MARY E. RODMAN RECREATION CENTER RENOVATION

CONTRACT NO. 20814

ADDENDUM NO. 1

For: SPECIFICATIONS AND DRAWINGS

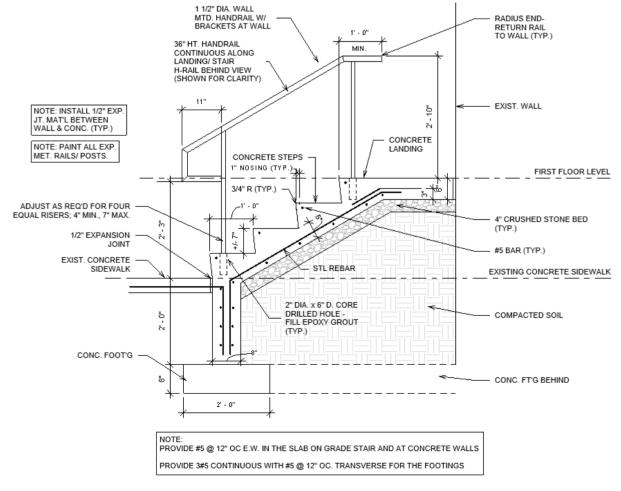
8) The interior elevation for Multi-Purpose Room 101 shown on Sheet A-400 has a note on "Interior Elevation A" which shows "2X4 (24" X 48") LAY-IN ACOUSTICAL TILE CEILING" above the cloud ceiling. First, is the contractor expected to install ACT-1 ceiling grid and tile throughout the entire Multi-Purpose Room 101 (including over the proposed cloud ceiling) and have cloud ceiling ACT-2 grid and tile installed below? Second, the 2x4 ACT contradicts the 2x2 ACT shown on sheet A-107. Can you confirm whether 2x2 or 2x4 ACT is scheduled for Room 101?

9) Can additional details be given for how the contractor is expected to install the cloud ceiling? Is this cloud ceiling proposed to appear open on all sides and hanging from a second grid ceiling above or is the cloud ceiling to have drywall and metal stud bulkheads installed vertically up to the structure above on the three sides that do not meet the perimeter wall, whereas the adjacent grid ceiling above would terminate at the new bulkhead?

Answer: This note is pointing to the ACT in in front of the ceiling cloud. There is not to be any ceiling tile above the ceiling clouds. These clouds will be suspended at different heights with a bulkhead above. Ceiling tile on the bottom of the clouds to be installed by the GC. The ceiling between the clouds will receive 2x2 ACT with new grid and tiles; this new grid, where adjacent to new ceiling clouds, will terminate at the new bulkheads.

Answer: Ceiling cloud is to have drywall and metal stud bulkheads installed vertically up to the structure above on the three sides that do not meet the perimeter wall. Yes, the adjacent 2x2 ACT grid will terminate at the new bulkhead.

NEW FLOOR PLAN

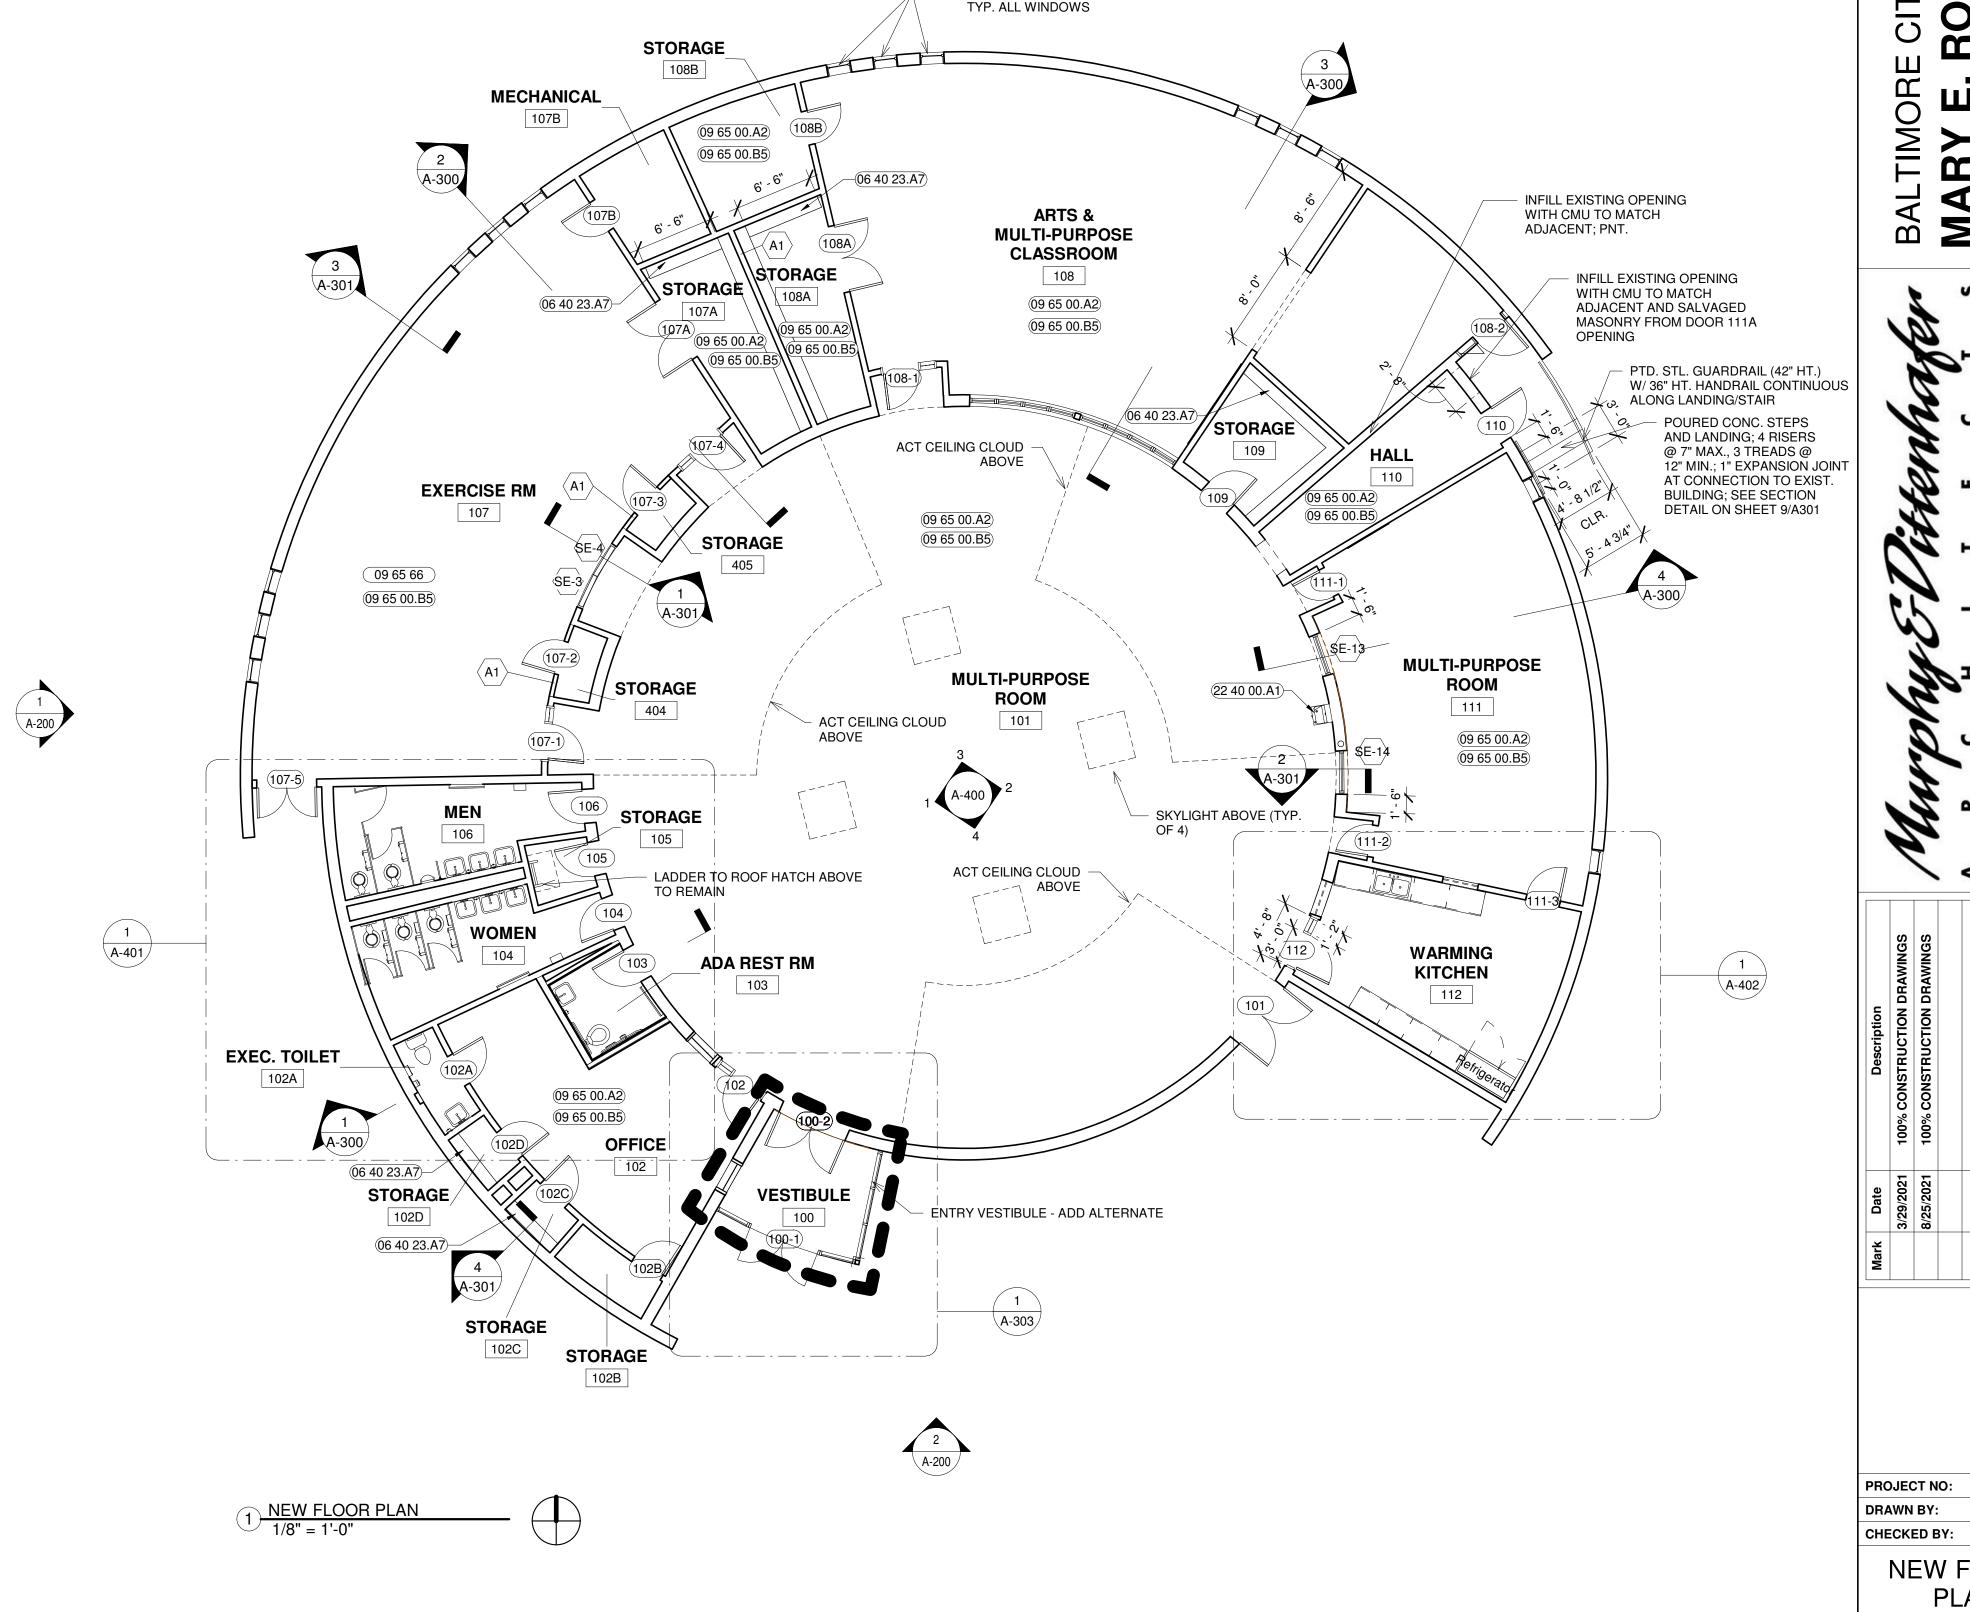
2.5 Sheet A-101, New Floor Plan

- 1. Floor Plan update in Exec. Toilet 102 A to show toilet tissue dispenser and sanitary napkin disposal unit
- 2. Floor Plan update in Women 104 to show middle sink, baby changing station and electric hand dryer
- 3. Floor Plan update in Men 106 to show baby changing station and electric hand dryer.
- 4. Floor Plan revised to Hall to be room number 110 and door to be door 110.
- 5. Floor Plan revised to show door 111-4 as 111-3
